Technical Note

Project: Earl Shilton, Leicestershire

Subject: Response to Leicestershire County Council's Comments

Client:	Vistry		
Project No:	09924	Version:	A
Document Ref:	09924-TN-02	Author:	Lewis Griffiths
Date:	25/06/2026	Approved:	Richard Ellam

Swept Path Analysis of Proposed Access Arrangement

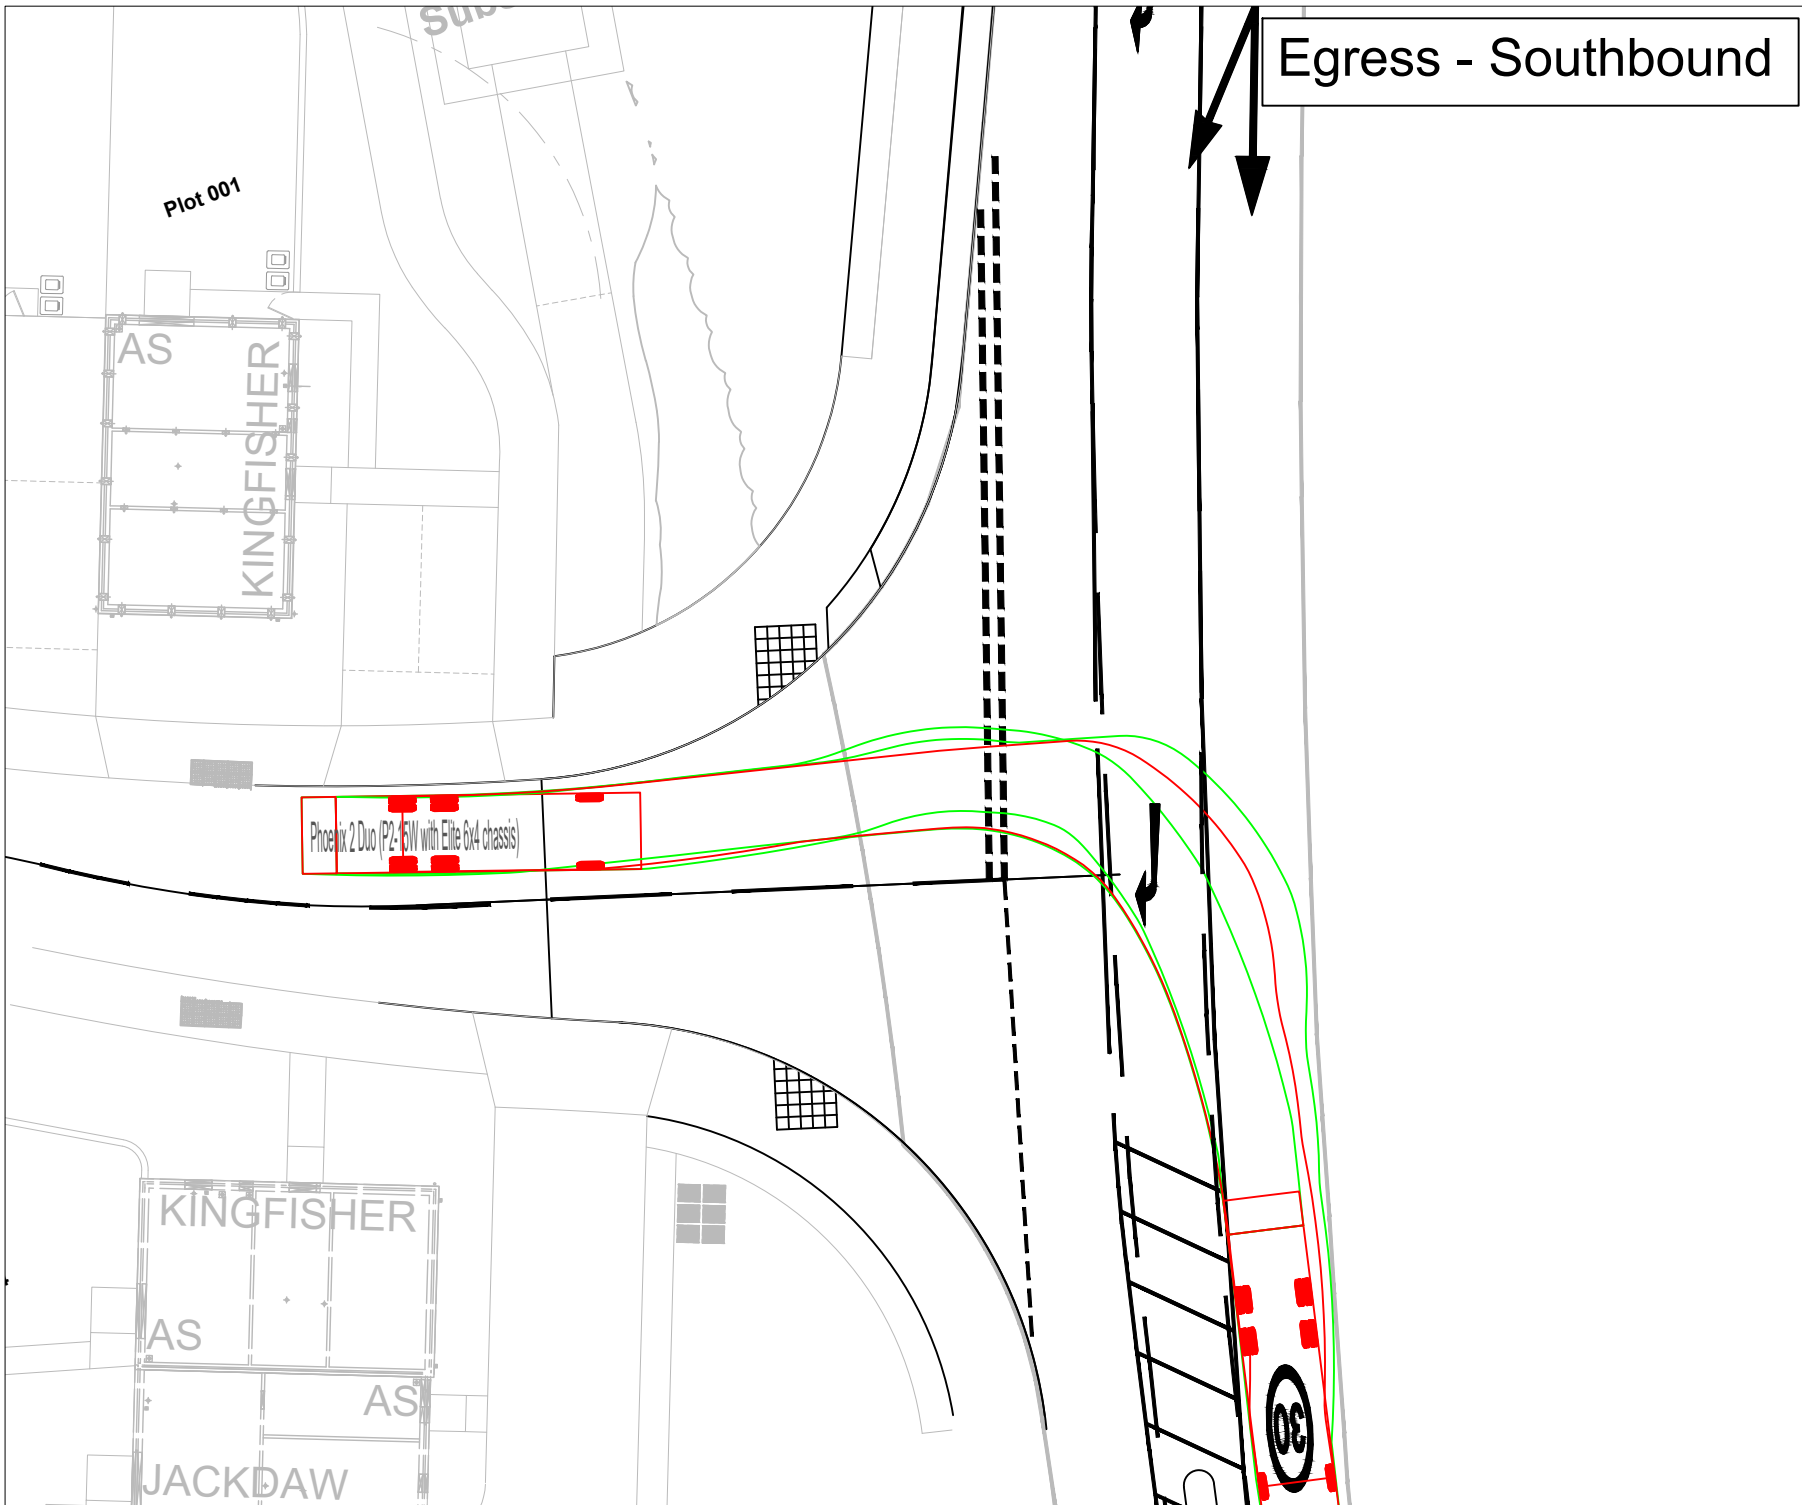
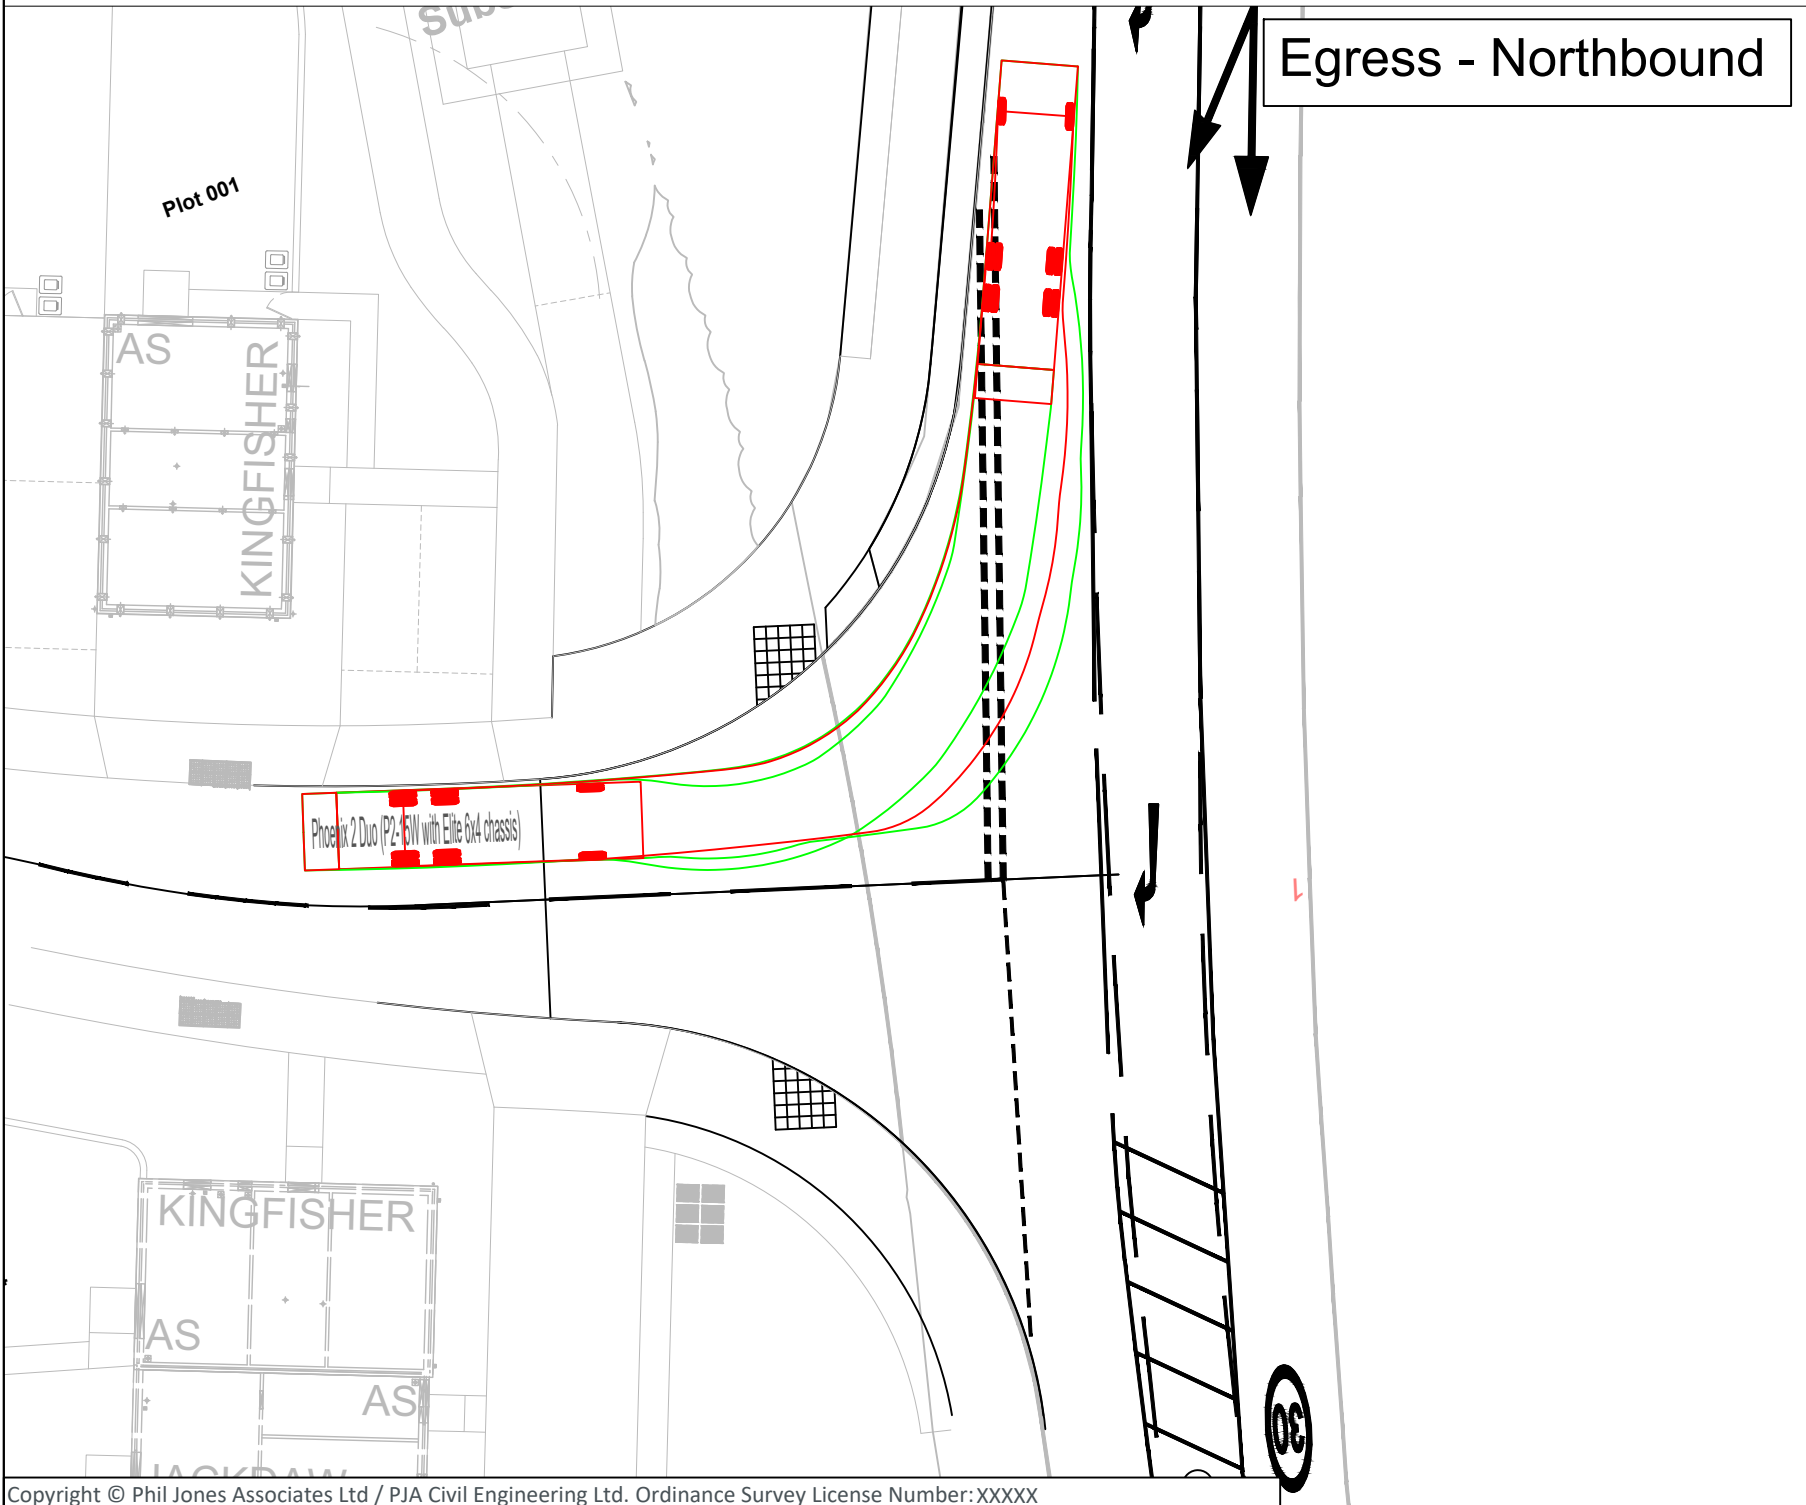
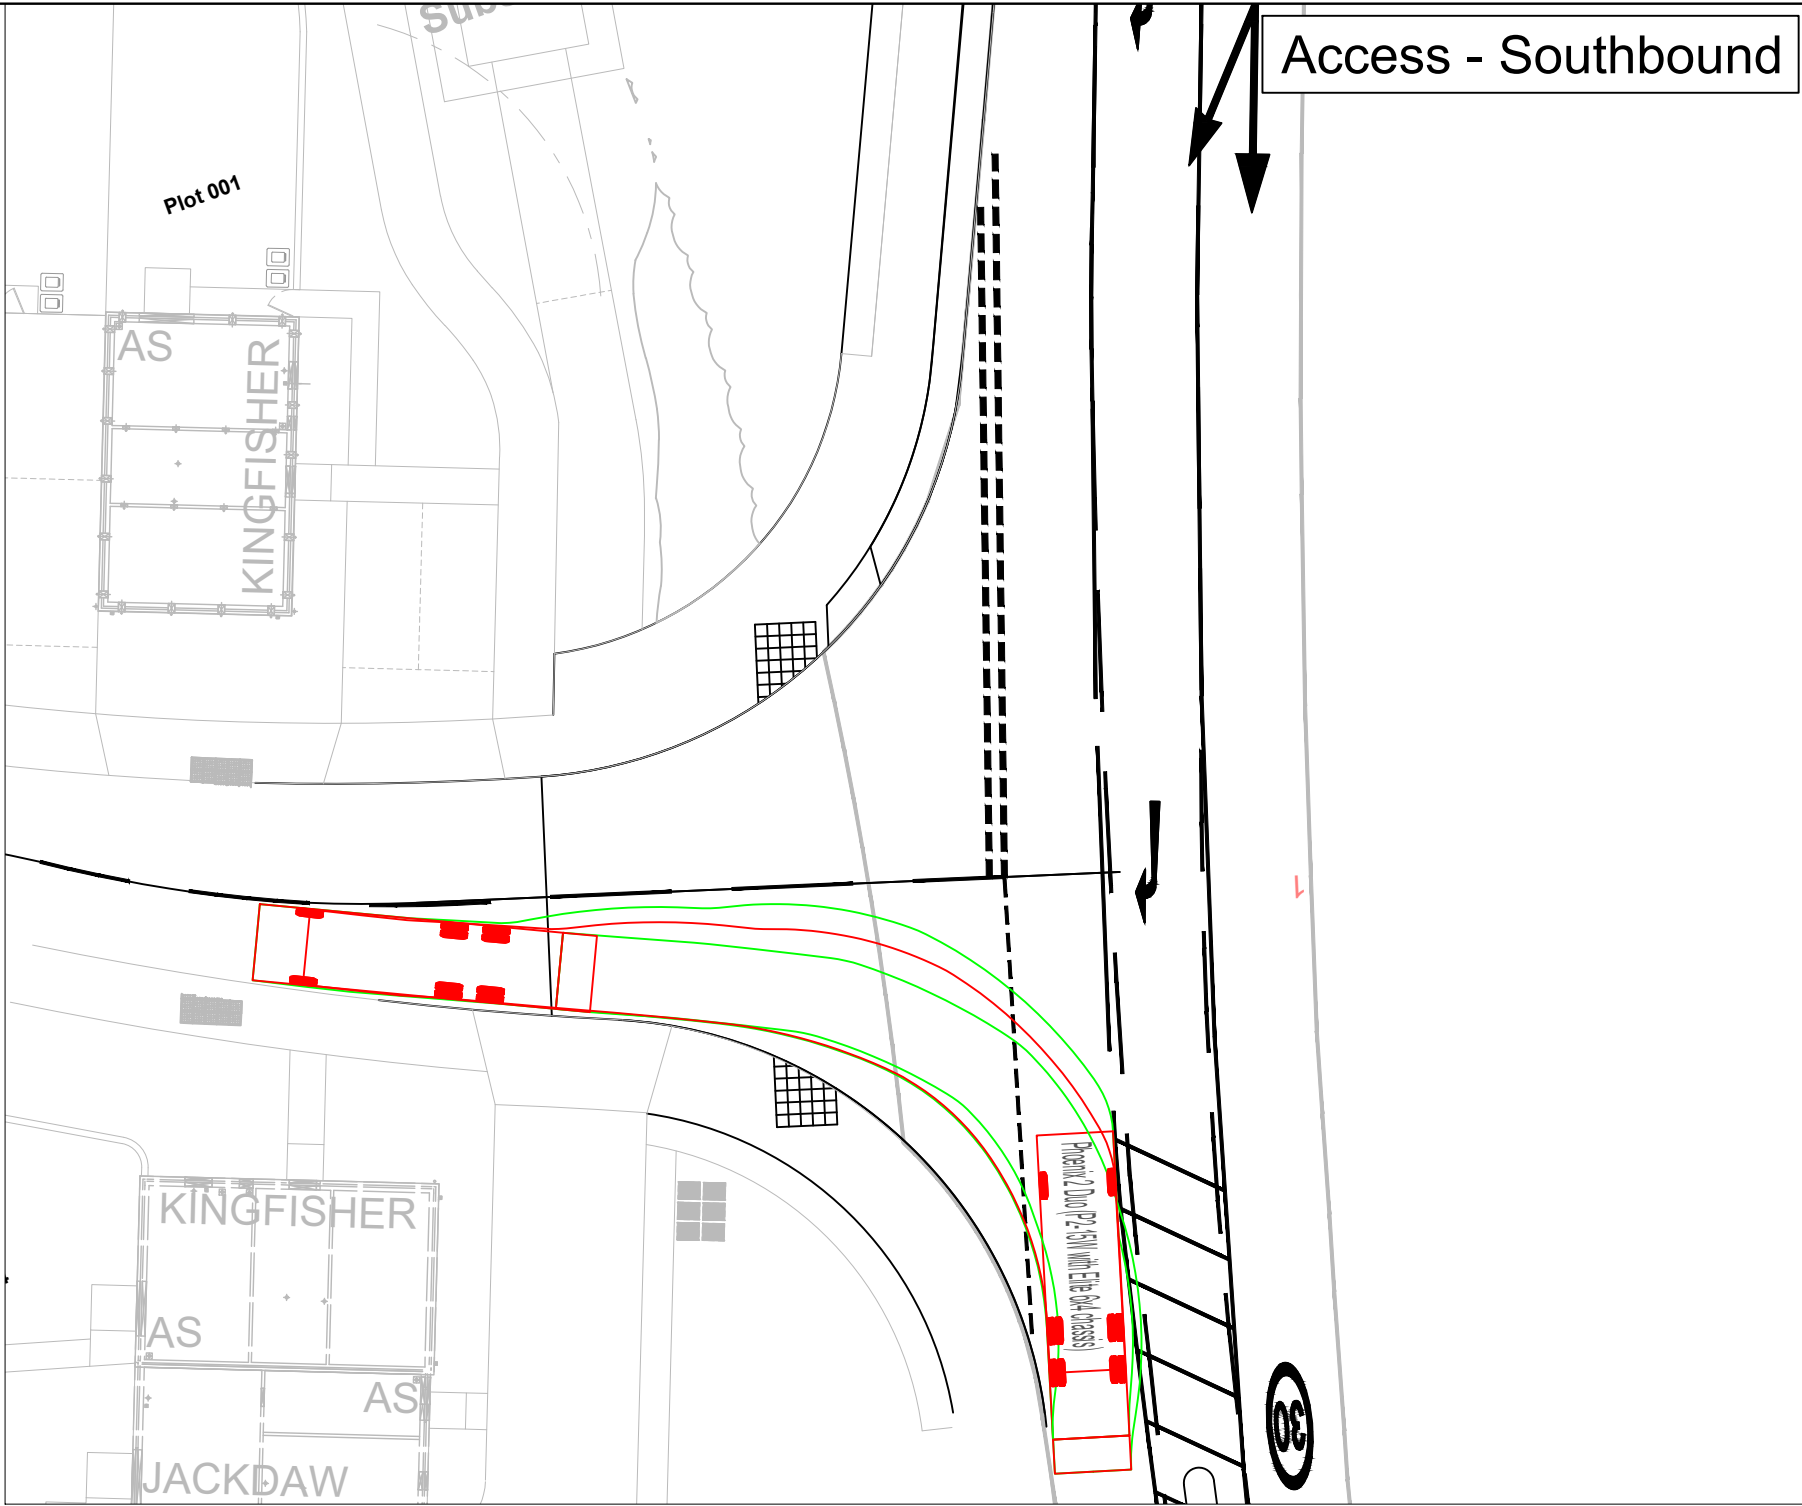
"No swept path analysis has been shown, which further adds to the concerns over the speed limit extension proposed above."

3.1.4 Swept path analysis has now been undertaken at the proposed access along with the right turn pocket provision. The swept path analysis was undertaken using an 11.2m refuse vehicle to provide a robust assessment as it is unlikely that a vehicle larger will require entry to the site. The swept path analysis is illustrated within drawing 09924.GA.02 provided in **Appendix E**.
